# **NIOSH Response to SC&A Review of ORAUT-OTIB-0081, Internal Coworker Dosimetry Data for the Savannah River Site**

**Response Paper**

November 25, 2019

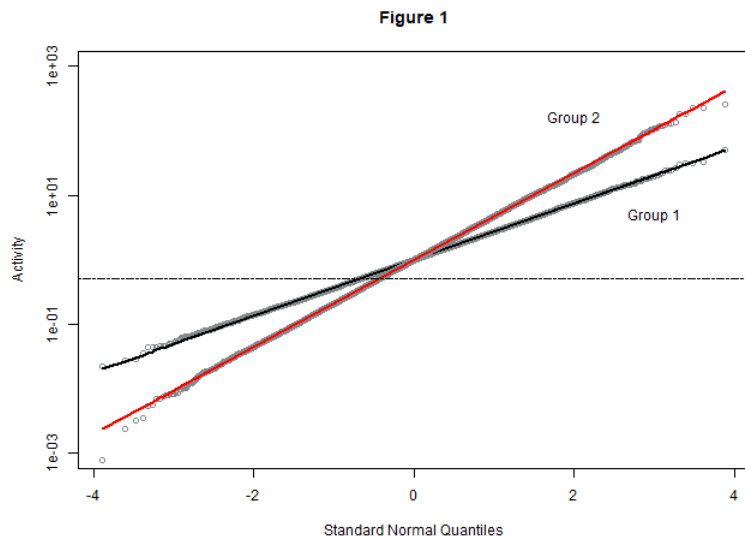
*While the multiple imputation method is mathematically correct, it has the potential to result in biasing the simulated bioassay results unnecessarily low. Alternate approaches, such as the maximum possible mean method, which replaces censored data with the actual censoring limit (or alternately one-half the censoring limit), would solve the issues associated with datasets containing a large number of censored values in a claimant-favorable manner (see section 3.2).*

The dashed horizontal line on the plot is at an activity of 0.5, just like in SC&A Figure 7. If we take the mean  $\bar{X}_1$  of the Group 1 data that are  $<0.5$  and the mean  $\bar{X}_2$  of the Group 2 data that are  $<0.5$ , by inspection it is obvious that  $\bar{X}_1 > \bar{X}_2$ . This is a property of how the example was constructed. Now assume that the data that are  $<0.5$  were not observed but were imputed. Once again  $\bar{X}_1 > \bar{X}_2$  because of the way the example was constructed, not because the data were imputed. Yet, using Figures 8 to 10 in their review, this is precisely the argument SC&A makes, i.e., because  $\bar{X}_1 > \bar{X}_2$  “... it [multiple imputation] has the potential to result in biasing the simulated bioassay results unnecessarily low.” The conclusions based on the discussion on pages 26 to 28 are based entirely on the arbitrary choice of the two distributions and have nothing to do with imputation—everything said applies to the complete datasets as well, as we have shown. On page 28, it is recommended that maximum permissible mean (MPM) be used in TWOPOS calculations instead of a time-weighted average of uncensored and imputed results simply because it is “claimant favorable.” The MPM is a statistically biased method that is technically wrong. The only reason MPM was used at all was because at the time there was no other method available to use in TWOPOS, the implementation of which was the primary objective. Multiple imputation is a technically correct, statistically unbiased method, which means that it can give lower values than MPM when used in a TWOPOS calculation. The recommendation to intentionally use a biased, technically inferior method should not be based simply on the fact that it gives higher results.

NIOSH considers multiple imputation to be a statistically sound approach to deriving unbiased parameter estimates of data distributions that contain censored data and is superior in all respects to the use of the maximum possible mean for such applications.

Consider the plot below, in which 10,000 random draws from a lognormal distribution LN(0,1) for Group 1 and 10,000 random draws from another lognormal distribution LN(0,1.545) for Group 2 are plotted against standard normal quantiles. This plot was constructed to mimic Figure 7 in the SC&A review, the main differences being that the data are not censored and there are a lot more data. As expected, both sets of data reveal their lognormality by being well fit with straight lines on this plot, albeit with different slopes and intercepts.

Whether imputed bioassay values are higher or lower is of little use when trying to interpret a coworker intake model because some percentile of the distribution of chronic intake is assigned to the worker, not the imputed values of censored bioassay results used to construct the coworker model. For example, in a coworker model, workers are usually assigned the 50th or 95th percentile of the distribution. Thus, although Group 2 has lower imputed values than Group 1, they have similar 50th percentiles and Group 2 has higher 95th percentile doses than does Group 1.
